NINE MILE POINT NUCLEAR STATION

SUBJECT: Nine Mile Point Nuclear Station
Unit No. 2; Docket No. 50-410

Response to Request for Additional Information Regarding Nine Mile Point Nuclear Station, Unit No. 2 – Re: The License Amendment Request for Extended Power Uprate Operation (TAC No. ME1476) – Fuel Storage Criticality Analyses

4.3.1.2 The new fuel storage racks are designed and shall be maintained with:

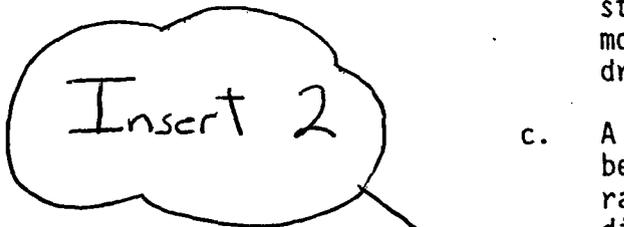
However, the PUSAR lists a peak in-core eigenvalue limit of 1.3392. Clarify this discrepancy and specify this limit in the TSs in accordance with 10 CFR 50.36. In addition, provide the in-rack maximum k-effective for new fuel storage determined by analysis and the supporting analysis.

The NRC requested that NMPNS add a limitation to the NMP2 Technical Specifications regarding the peak in-core eigenvalue of any constituent fuel lattice for the new fuel storage. In response to this request, NMPNS proposes to add the following to the NMP2 Technical Specifications:

Insert 2

Insert 2

4.3.1.2...

- d. Fuel assemblies having a maximum k-infinity of 1.34 in the normal reactor core configuration at cold conditions; and
- e. Fuel assemblies having a maximum U-235 enrichment of 4.9 weight percent.
